INDIANA DEPARTMENT OF TRANSPORTATION

Design Memorandum No. 16-36 Technical Advisory

SUBJECT: Pedestrian Pushbutton Assemblies Plan Details Required for
New and Relocated Assemblies

REVISES: *Indiana Design Manual 51-1.06 and 502-3.03(05), item 4*

Figure 51-1P

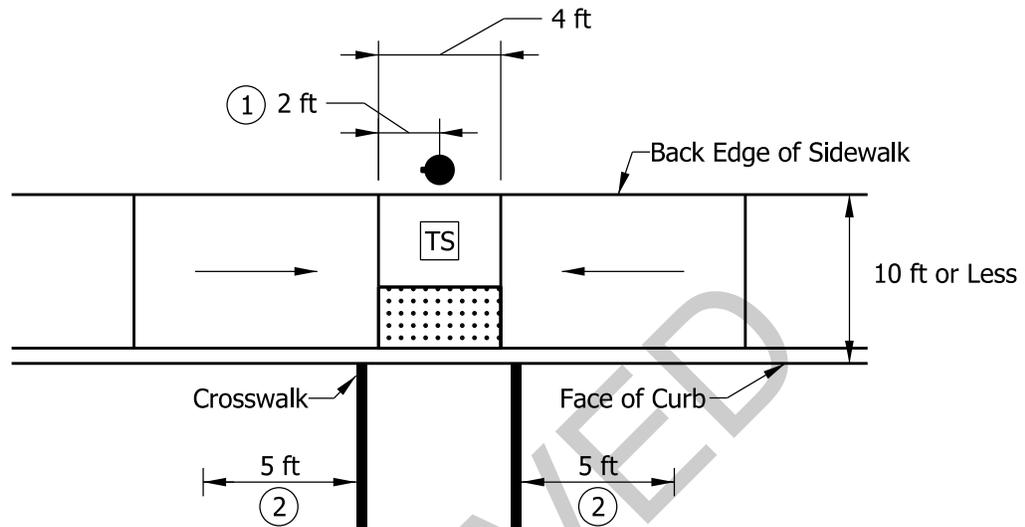
The running slope and cross slope of a pushbutton clear space are based on the orientation of the pushbutton assembly. See [Figure 51-1P](#), Pushbutton Clear Space. The running slope may be consistent with the grade of the sidewalk. The cross slope must be 2.00% maximum.

① The minimum required clear dimensions of a pushbutton clear space are 4 ft by 4 ft.

Figure 51-1Q

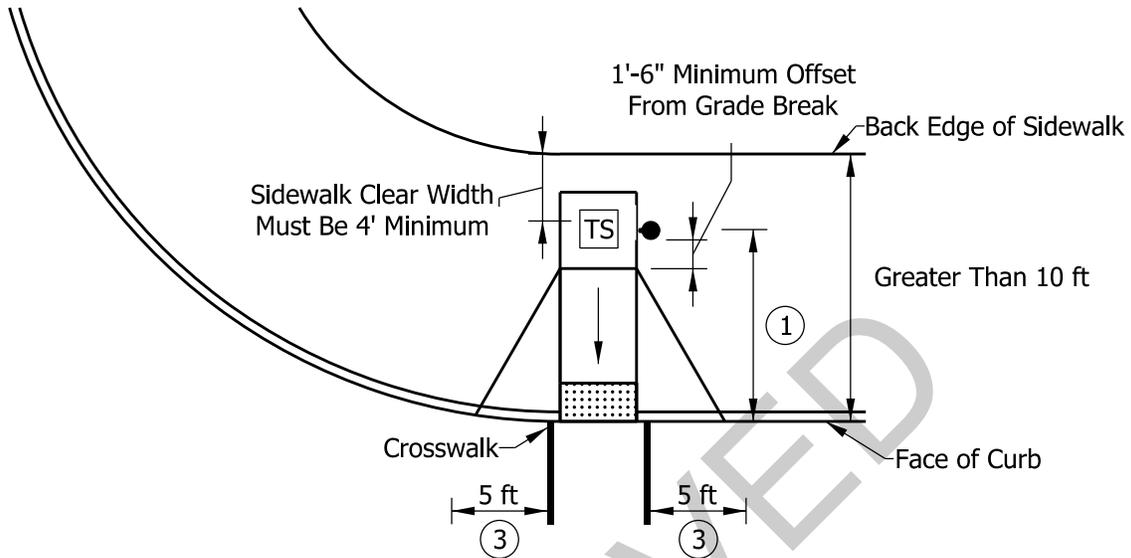
- a. Pedestrian Pushbutton Assembly Outside the Back Edge of Sidewalk. A pedestrian pushbutton assembly should not be placed more than 5 ft outside the associate crosswalk. A pushbutton assembly should be centered adjacent a pushbutton clear space. See [Figure 51-1Q](#), Pedestrian Pushbutton Assembly Outside the Back Edge of Sidewalk, Preferred.

- ① A pushbutton assembly should be centered adjacent a pedestrian clear space and centered relative to the crosswalk. Overlapping a pushbutton clear space with a curb ramp turning space is preferred.
- ② A pushbutton assembly should not be placed more than 5 ft outside the crosswalk. A pushbutton assembly may only be placed adjacent a ramp with a running slope of 2% or less.

Figure 51-1R

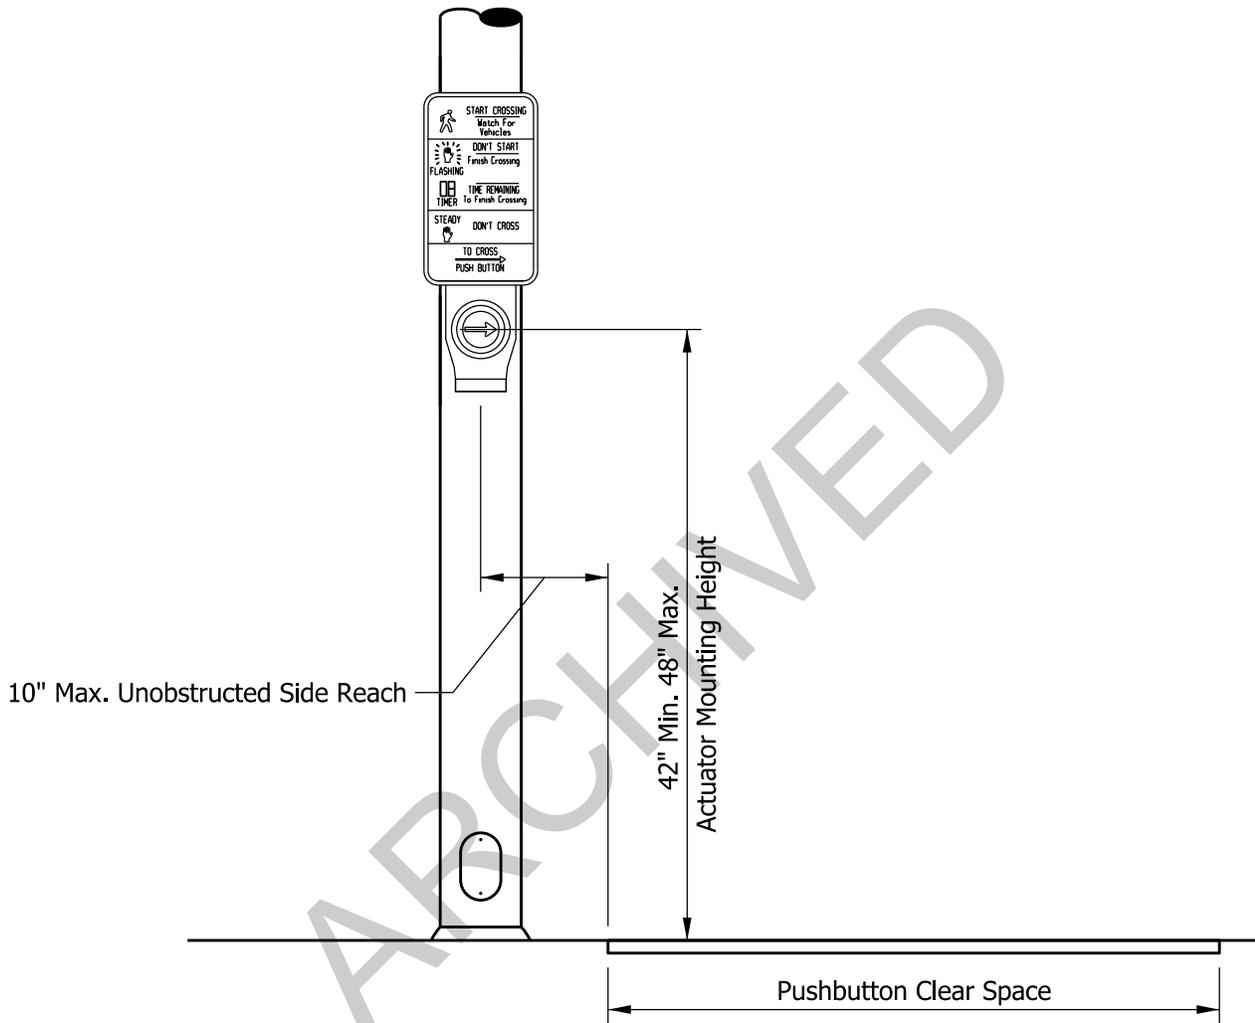
- b. Pedestrian Pushbutton Assembly Within a Sidewalk or Buffer. A pedestrian pushbutton assembly should not be placed more than 5 ft outside the associate crosswalk. A pushbutton assembly should be adjacent a pushbutton clear space. Centering on the pushbutton clear space is not required, however the grade break guidance in Item 3 would apply.

The distance from the nearest face of a pushbutton assembly to face of the curb or edge of pavement should be between 1.5 ft and 6 ft and should not be greater than 10 ft. A minimum offset of 1.5 ft from the face of curb or edge of pavement will allow a wheelchair user to remain out of traffic while actuating the pushbutton assembly. A minimum offset of 1.5 ft also provides an appurtenances-free zone along the roadway. See [Section 55-5.02](#), Item 5.

A 4-ft minimum sidewalk clear width must be provided where a pushbutton assembly is placed within a sidewalk.

- ① The distance from a pushbutton assembly to face of the curb or edge of pavement should be between 1.5 ft and 6 ft and should not be greater than 10 ft. A minimum offset of 1.5 ft from the face of curb or edge of pavement will allow a wheelchair user to remain out of traffic while actuating the pushbutton assembly. A minimum offset of 1.5 ft also provides an appurtenances-free zone along the roadway.
2. A pedestrian pushbutton assembly should be adjacent a pedestrian clear space. Overlapping the pushbutton clear space with a curb ramp turning space is preferred.
- ③ A pushbutton assembly should not be placed more than 5 ft outside the crosswalk. A pushbutton assembly may only be placed adjacent a ramp with a running slope of 2% or less.

Figure 51-1S

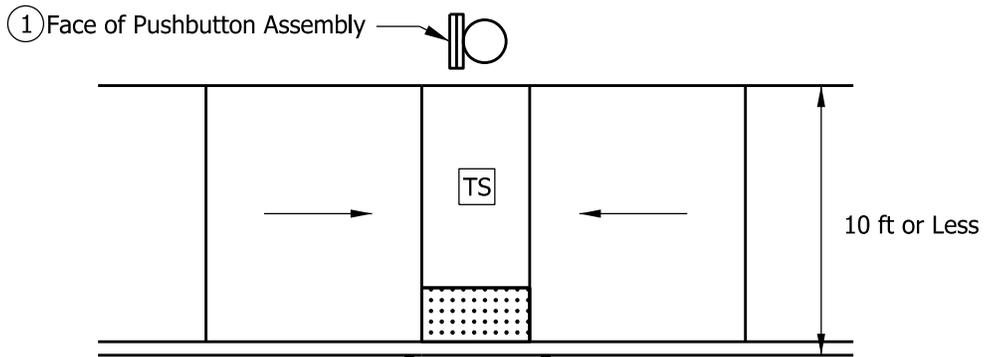
5. Mounting Height and Side Reach. [R406] The actuator of the pedestrian pushbutton assembly must be located between 42 in. and 48 in. above the pushbutton clear space and within a 10-in. unobstructed side reach. See Figure 51-1S, Pedestrian Pushbutton Assembly Mounting Height and Side Reach. Where pole placement is limited, a 6 in. or 12 in. pushbutton assembly extension may be used to meet the side reach criteria.
